SERVICE BULLETIN

Bulletin No. 03-09
March 31, 2009

Subject: Fluid Nozzle O-Ring on Vector Solo Cordless Guns

Figure 1 SOLO R90/R70 O-RING REMOVED DIAGRAM

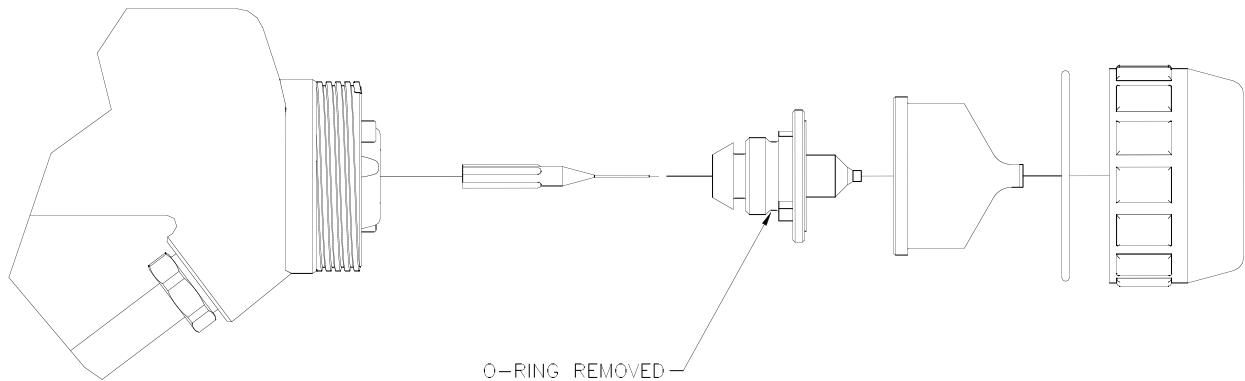
The o-ring on the fluid nozzle (79377-xx or 79552-xx) is no longer required. Any future shipments of Solo applicators models 79900, 79901 and 79965 will not have the o-ring shipped installed. The design of the Solo is such that the o-ring had little or no effect on the fan pattern size.

If you have an older Solo model, when you perform maintenance on the product, the o-ring should be removed. Insure that when the nozzle is re-installed it is properly torque in place.
